**TRANSMITTAL OF RESPONSES TO OHIO ENVIRONMENTAL PROTECTION AGENCY
COMMENTS ON THE DRAFT CERTIFICATION DESIGN LETTER FOR AREA 1, PHASE II
SECTOR 3 UTILITY TRENCHES**

**RESPONSES TO OHIO ENVIRONMENTAL PROTECTION AGENCY COMMENTS
ON THE DRAFT CERTIFICATION DESIGN LETTER
FOR AREA 1, PHASE II SECTOR 3 UTILITY TRENCHES
(REVISION A)**

FIGURE 1. SAMPLE LOCATIONS

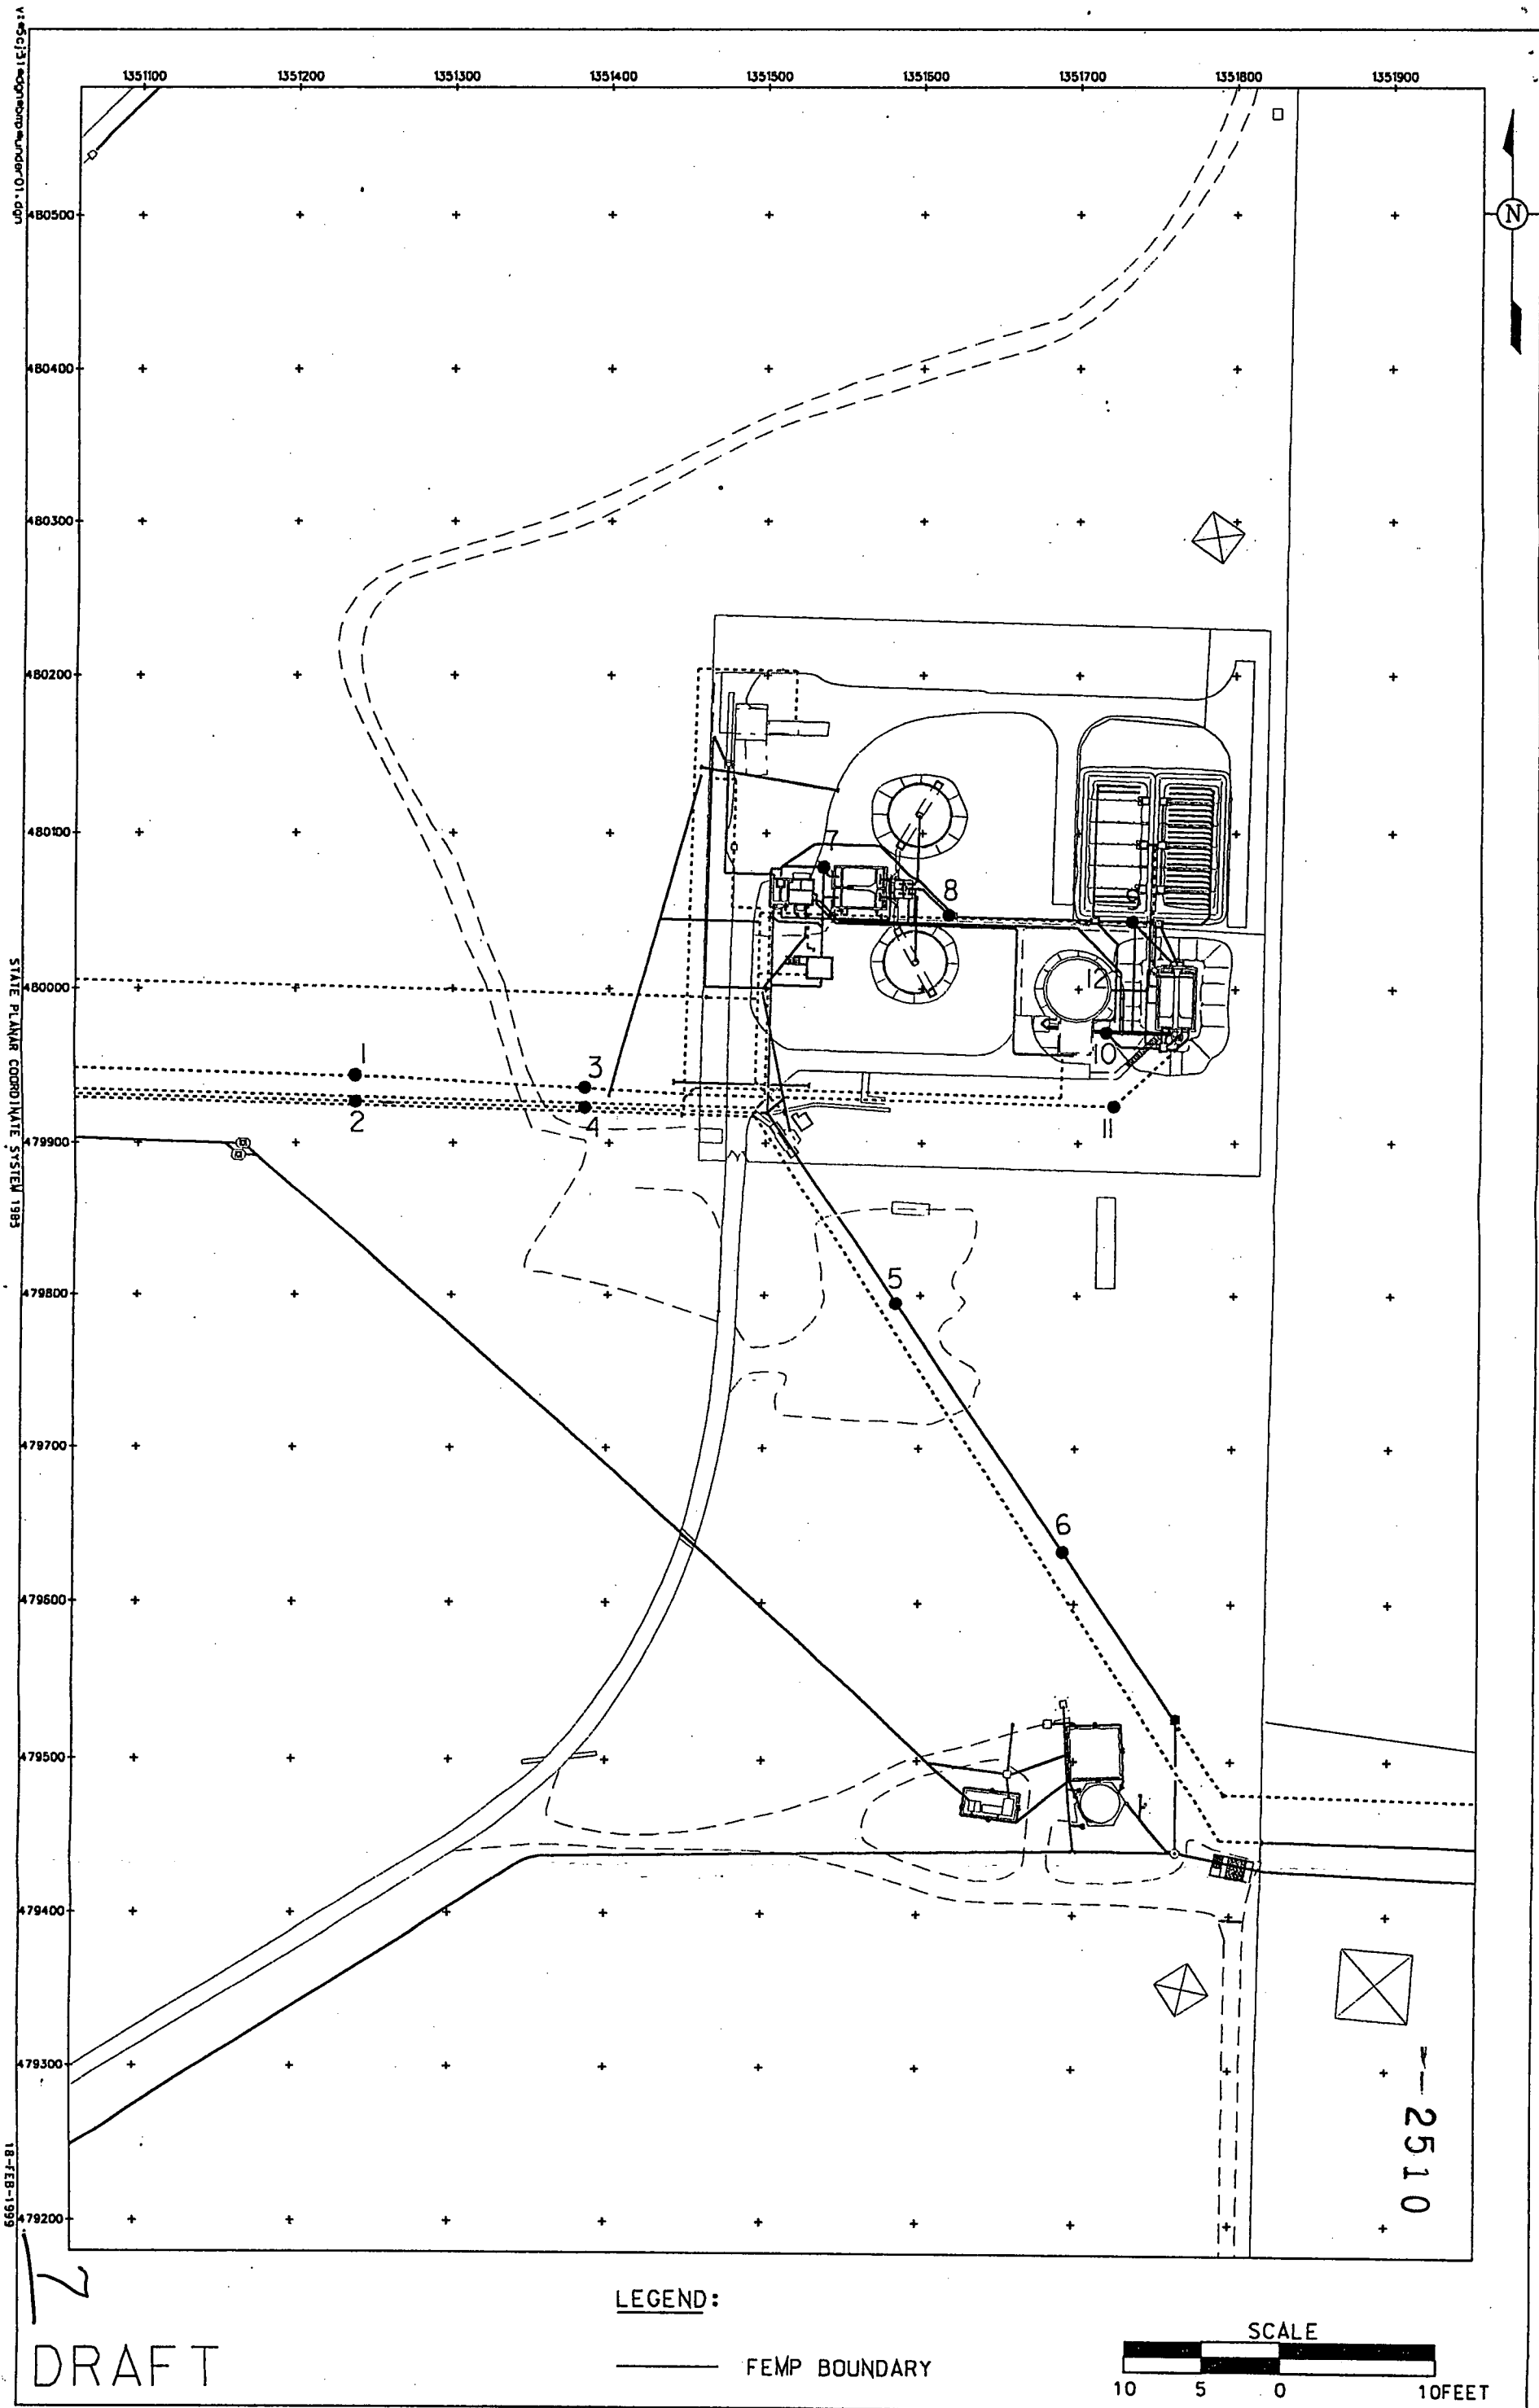
This variance documents the addition of additional sampling of pipe bedding material at 6 locations inside STP and 6 outside the STP as shown on Figure 1. The following table lists the sample identification labels, locations, and Target Analyte List.
